ATTACHMENT 2

PROPOSED TECHNICAL SPECIFICATION

Marked-up Technical Specifications Pages.

Values which have changed as a result of this review are shown as "ballooned" changes. The other changes shown were submitted previously under letter L-90-417.

TABLE 3.3-3 (Continued)
ENGINEERED SAFETY FEATURES ACTUATION SYSTEM
INSTRUMENTATION TRIP SETPOINTS

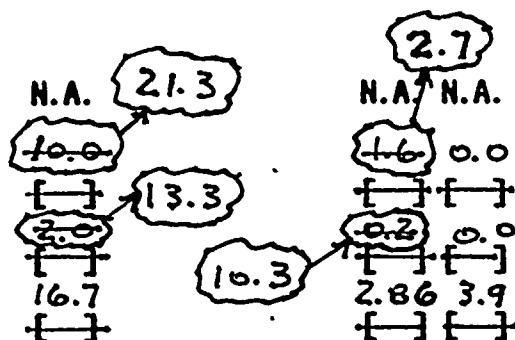
- b. Automatic Actuation Logic and Actuation Relays
- c. Containment Pressure--High
High Coincident with:
Containment Pressure--High
- f. Steam Line Flow--High

<A function defined []

as follows: A Δp corresponding to 0.64×10^6 lbs/hr at 0% load increasing linearly to a Δp corresponding to 3.84×10^6 lbs/hr at full load.

40% steam flow

from 20% load to a value

120% steam flow

≤ A function defined as follows: A ΔP corresponding to 42.6% Steam Flow at 0% load increasing linearly from 20% load to a value corresponding to 122.6% steam flow at full load.
